**Landscape Review Committee**  
**Community Development Center, 231 NE 5<sup>th</sup> Street**  
**July 18, 2018**  
**12:00 PM**

## **EXHIBIT 1 - STAFF REPORT**

**DATE:** July 18, 2018  
**TO:** McMinnville Landscape Review Committee  
**FROM:** Jamie Fleckenstein, Associate Planner  
**SUBJECT:** Agenda Item 4A: L 18-18

An application for a landscape plan for a new commercial shell building (L 18-18) to be reviewed by the Landscape Review Committee.

Site Plan with Landscape and parking  
1"=20'

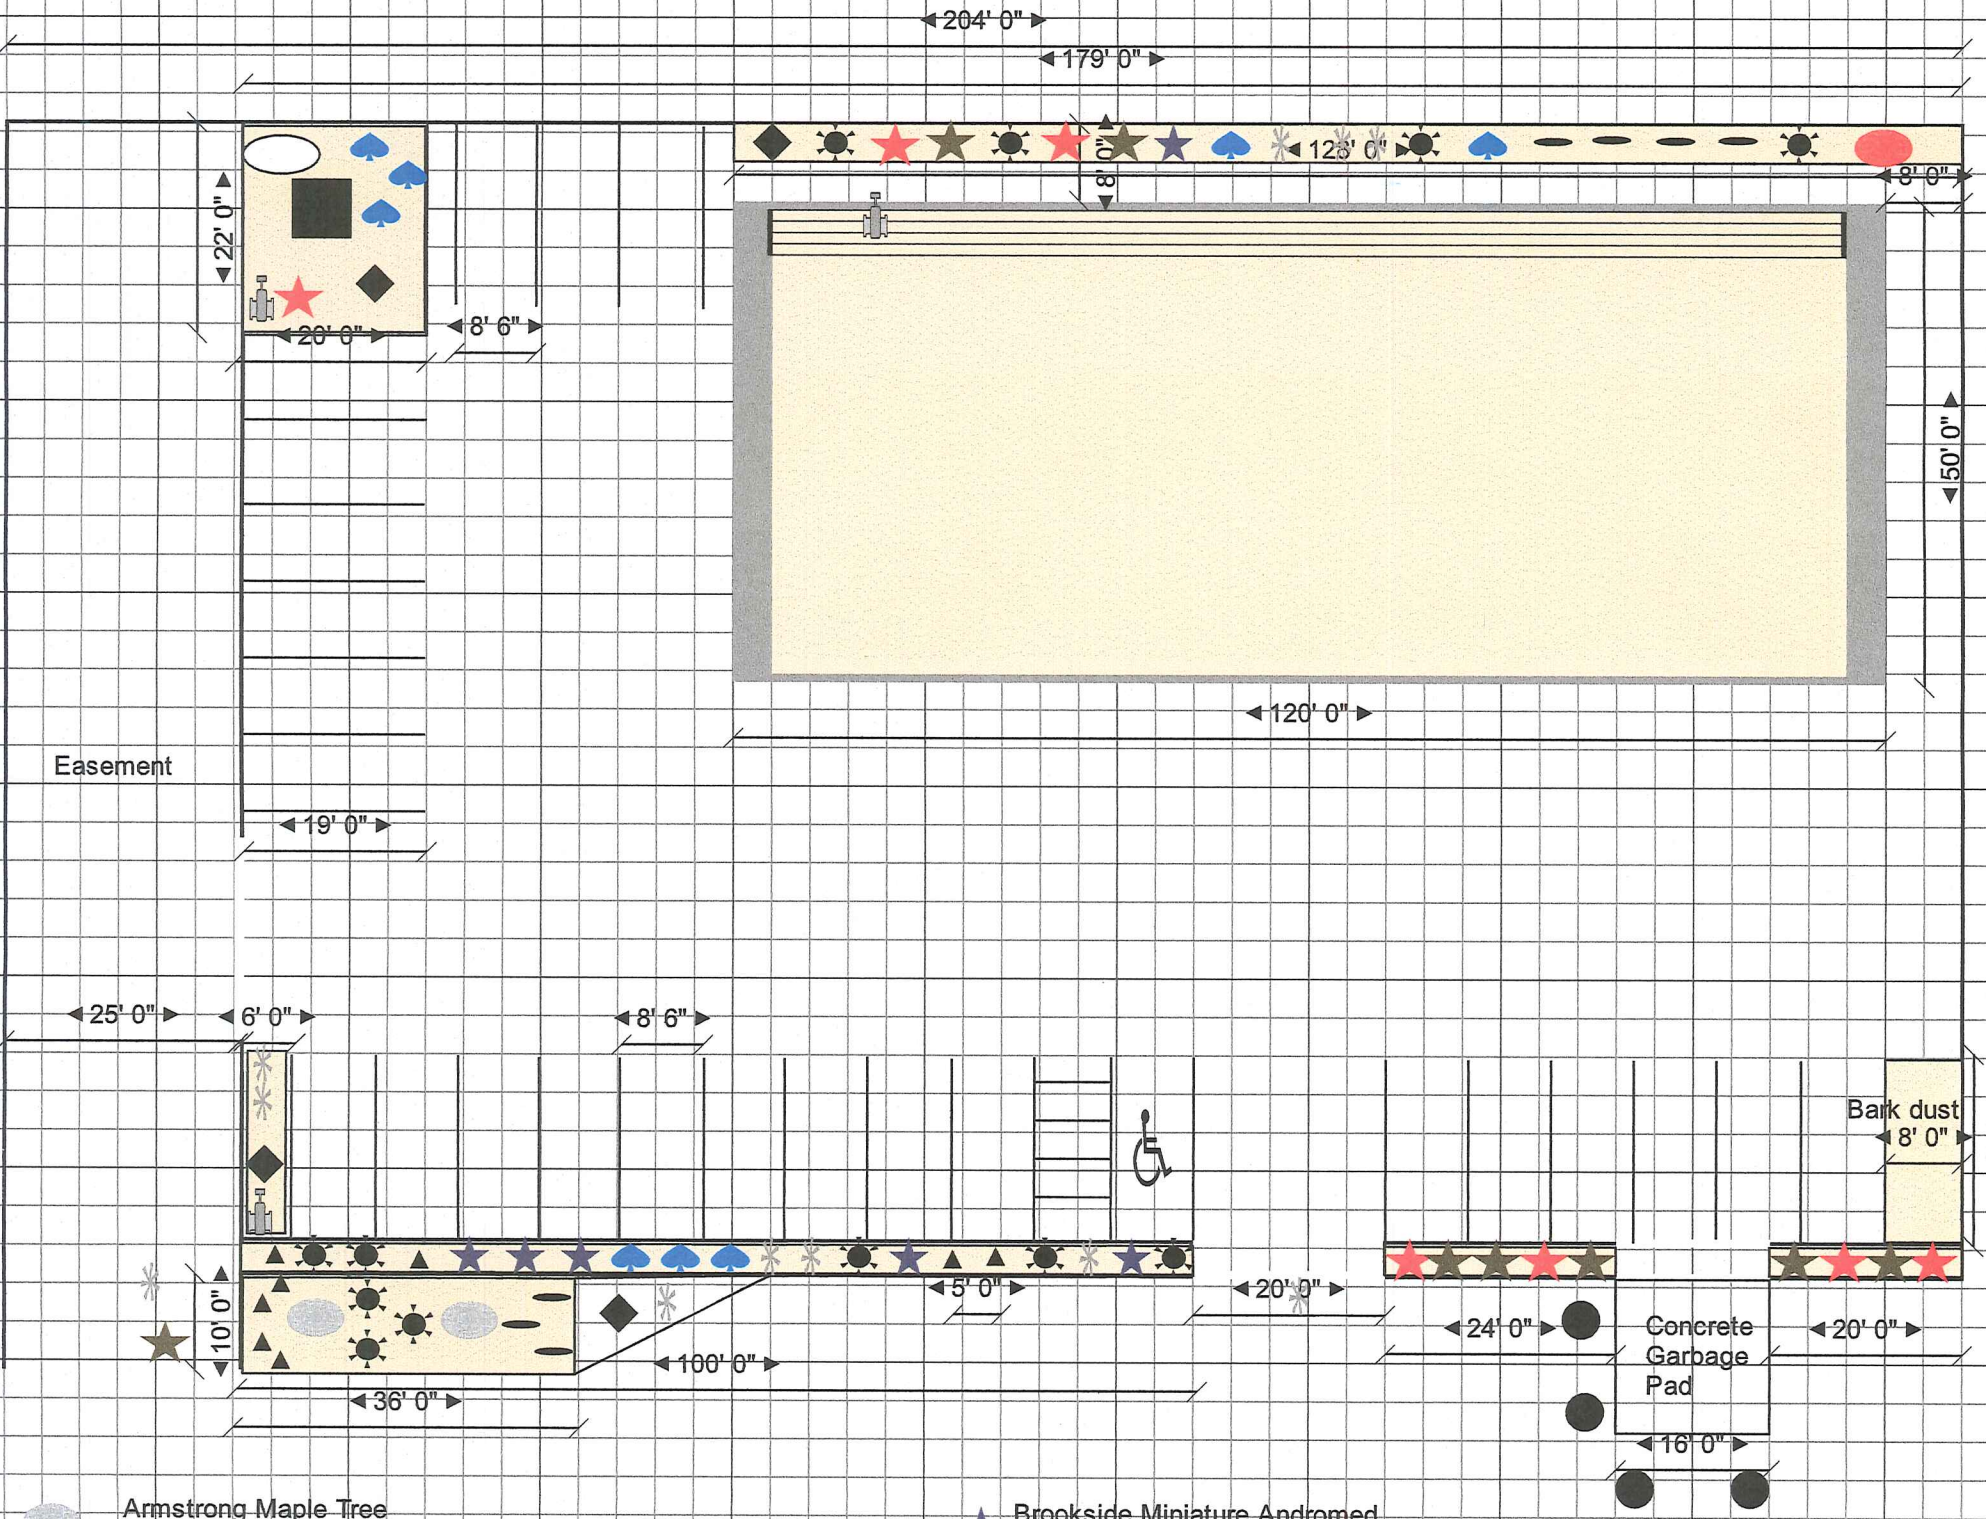
The landscape plan proposes planting around the perimeter of the proposed development site. In the southeastern corner of development, the applicant is proposing a landscape strip in front of the new parking and planting on 2 sides of a proposed concrete garbage pad, and an 8' x 20' area of bark dust at the end of the parking spaces. The width of the proposed planting strip in front of the parking is 3', and plants proposed for this location are Carex grass (species not indicated) and Miscanthus grass (species not indicated). The width of the planting bed around the garbage area is not indicated. The applicant is proposing four (4) small laurels (species not indicated) in this location.

Along the southwest edge of development, more landscaping is being proposed in front of the new parking. In a landscape strip measuring 3' wide, the applicant is proposing a combination of Dwarf Golden Japanese Yew (*Taxus cuspidata* 'Nana Aurescens') growing 3 feet tall by 5 feet wide at maturity, Brookside Miniature Andromeda (*Pieris japonica* 'Brookside Miniature') growing 2-4' x 2-3', Little Heath Japanese Variegated Andromeda (*Pieris japonica* 'Little Heath') growing 3-4' x 3-4', Boxwood (species not indicated), Mary Poppins Azalea (*Rhododendron* 'Mary Poppins') growing 3-4' x 3-4', and a single Tigers Eye (botanical name not provided). In a larger landscaping area on the SW corner of development, the applicant is proposing two (2) Armstrong Maples (*Acer rubrum* 'JFS-KW78') a columnar tree growing 35-40' tall. Under the trees, Boxwood, Dwarf Golden Japanese Yew, Golden Glow Korean Fir (*Abies koreana* 'Golden Glow') growing 6' x 12', Little Heath Japanese Variegated Andromeda, and a Tigers Eye (botanical name not provided).

At the northwest corner of the proposed development, the applicant has proposed a landscaping area measuring 22' x 20' around an existing transformer and a new water meter. Proposed plants in this area include Carex grass, Tigers Eye (botanical name not provided), and Mary Poppins Azalea. The applicant is also proposing to keep an existing 4' x 4' patch of flowers. No indication of the variety of existing flowers is made.

Along the north side of the building, a planting strip measuring 128' x 4' is proposed. Planting suggested for this area include a combination of Tigers Eye (no botanical name provided), Dwarf Golden Japanese Yew, Carex grass, Miscanthus grass, Brookside Miniature Andromeda, Mary Poppins Azalea, Little Heath Japanese Variegated Andromeda, and Golden Glow Korean Fir. The site plan indicates an existing tree of unknown species and 6-8' in height will remain at in the northeast corner of the proposed development area.

More information is required to determine if the proposed landscape plan will be compatible with the proposed project and the abutting uses. Landscape areas in front of new parking spaces may not be appropriately sized for proposed plants.

Based on the information provided in the application, it does not appear that the proposed use will be adequately screened. No landscaping areas are proposed adjacent to the building. No planting is proposed along the western edge of the development to screen new parking from adjacent properties. Without clarification of specific plant species, the amount of screening provided by the proposed landscaping on the south edge of the developed area is difficult to determine. The two (2) proposed columnar maple trees in the SW corner of the site will provide some screening and shading of the adjacent parking. No fencing or other screening methods are indicated on the site plan. An existing row of mature trees screens and buffers the eastern edge of the property, but there is no indication of

The site plan indicates 25 new parking spaces are proposed around the new commercial building. The applicant has proposed landscape areas at some ends of the parking bays, and there are no internal islands shown. Planting strips in front of parking spaces to the south are 3' in width, and there is no proposed planting in front of new parking spaces to the west.

The applicant proposes a drip irrigation system for all new landscape areas, except in the southeast corner of the developed area. There, applicant proposes no irrigation and will water the 24'x3' and 20'x3' planting areas in front of the parking and the planting around the garbage area by hand. No water would be necessary for the 20' x 8' area where only bark dust is proposed.

Based on the findings described above, staff is recommending that the landscape plan be continued. The continuation of the landscape plan is being recommended so that additional information can be provided to determine whether the landscape review criteria are being satisfied. Specifically, staff suggests that the Landscape Review Committee request the following additional information:

- 1. Botanical names of all plant materials being proposed.
- 2. Revision of planting area dimensions to accommodate proposed plant material, or revision of proposed plant material.
- 3. Clarification on status of existing mature trees and their inclusion on the landscape plan.
- 4. Addition of planting area to break up new parking spaces to the west.

5. Photos or clarification of existing plants recommended for saving.
